H11292

## DESCRIPTIVE REPORT

# Descriptive Report to Accompany Hydrographic Survey H11292

Project S-N904-RA-04  
Lake Washington, Washington  
Scale 1:10,000  
March 2004

Figure 1. H11292 Survey Limits and Junction

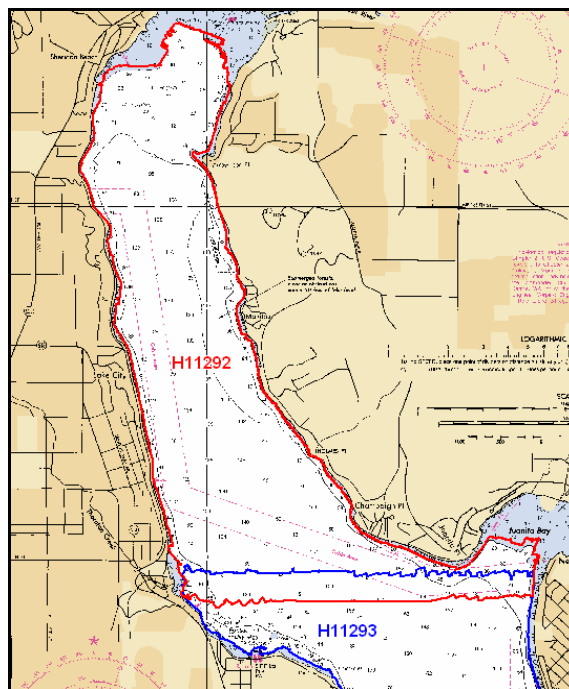
A cursory comparison with survey H11293 indicates differences are generally less than 2 feet throughout the junction area.<sup>4</sup>

<sup>4</sup> Concur, the junction with survey H11293 is complete. A *Joins* note has been added to the smooth sheet.

Figure 2. Milfoil cleaned from continuous bottom.

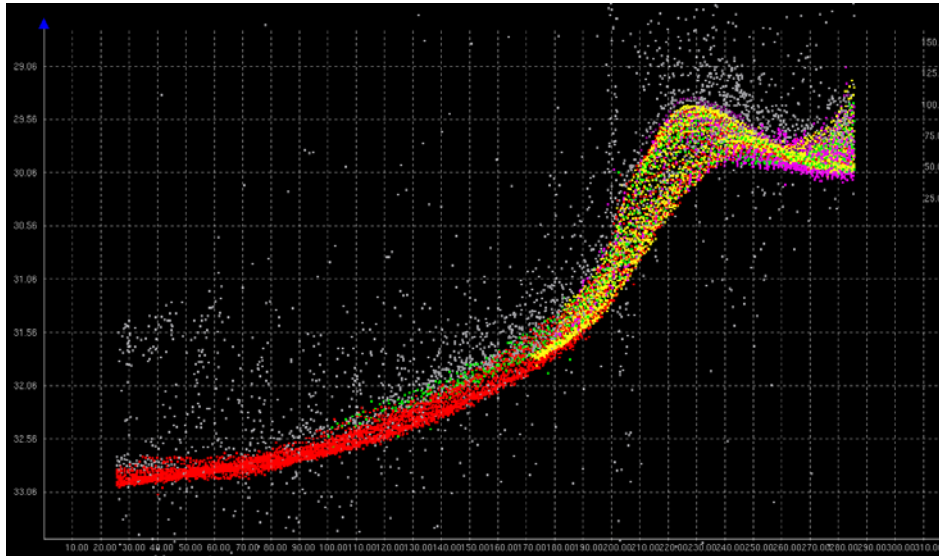
In many areas near shore, thick milfoil obscured sonar detection of the bottom. In the SWMB data, removal of soundings obtained over milfoil was not possible in HDCS SwathEdit, as there is no definitive way to determine if a sounding is on a feature such as a rock, or on milfoil. In HDCS Subset Mode, in some instances, it was possible to discern the true bottom, as the milfoil often appeared as soundings “disconnected” from the continuous bottom (Figure 2). In these instances soundings over milfoil were rejected. However, when unable to clearly distinguish between the bottom and the milfoil in multi-beam and backscatter data, the soundings were not rejected. <sup>5</sup>

<sup>5</sup> Additional editing was done during office review of this survey to remove noise and inaccurate depths.

Figure 1.5.1

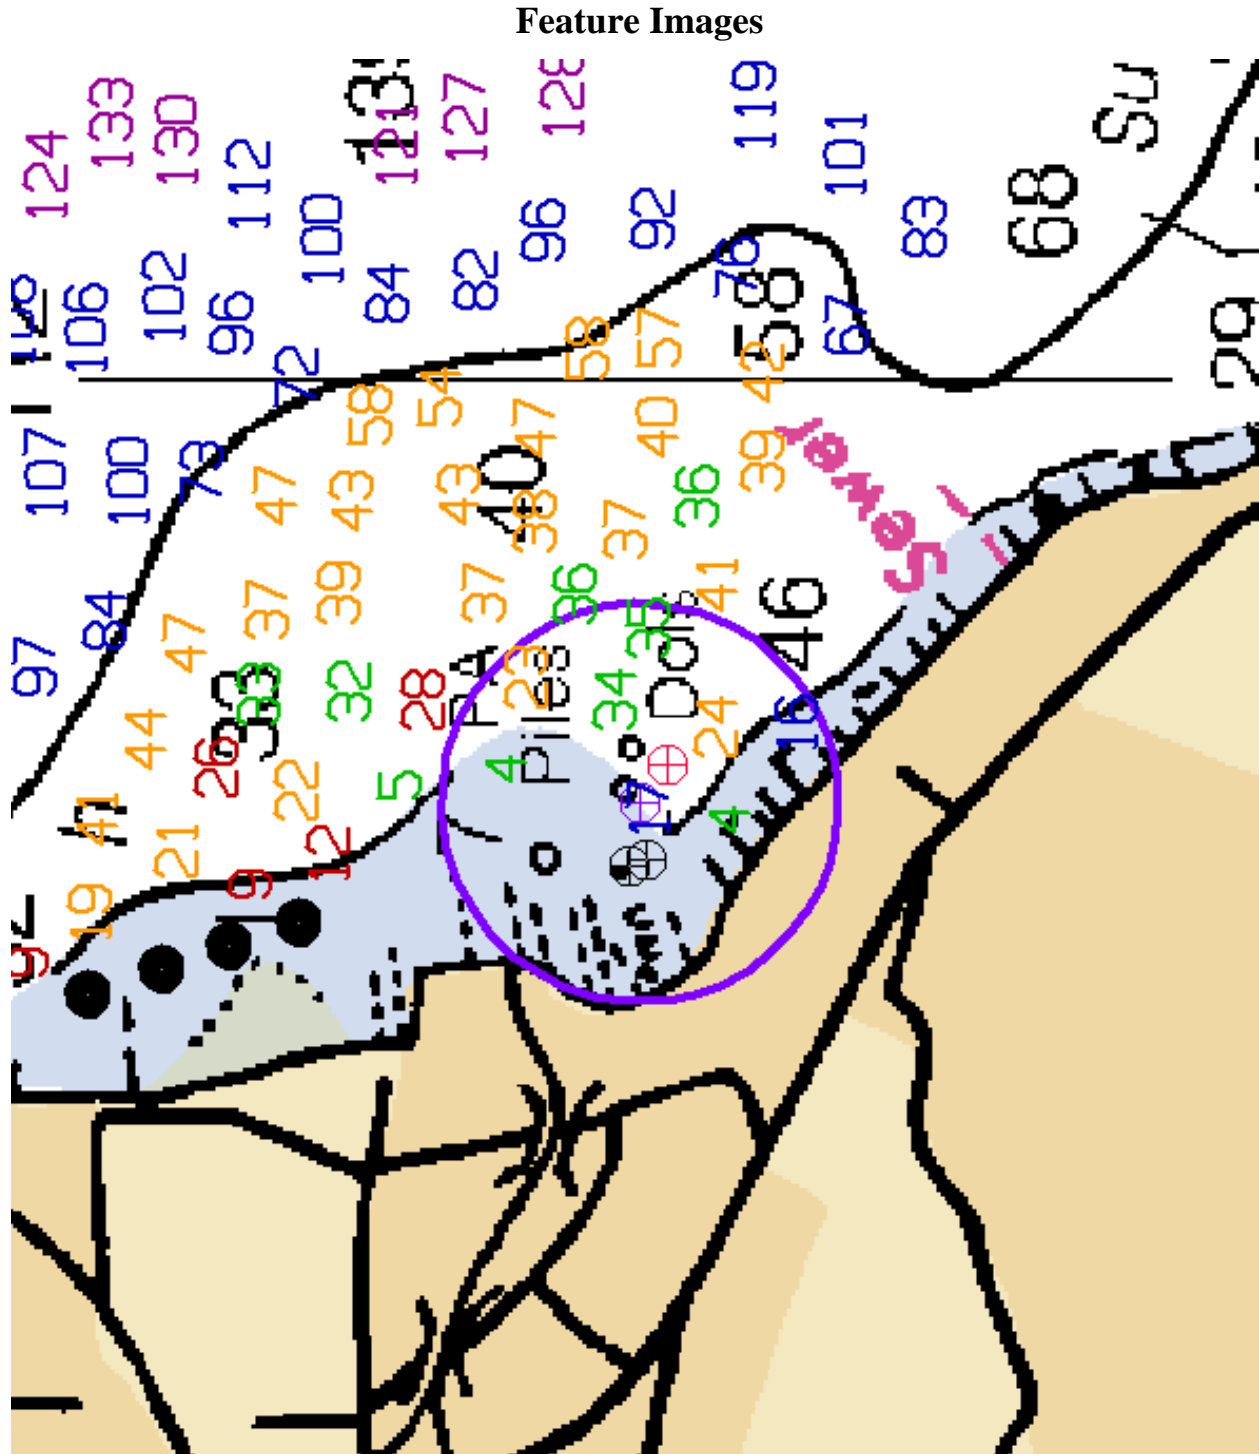
Chd (18447) Dolphin

Obts., AWOIS #53091

INVESTIGATION SUMMARY: Search radius was covered with 100% SWMB and dolphins were located and detached positions recorded (DP #1006\_302\_1016 and DP #1006\_302\_1017).

Reposition Charted (18447) Dolphin

Concur, chart MHW dolphin at the survey position.
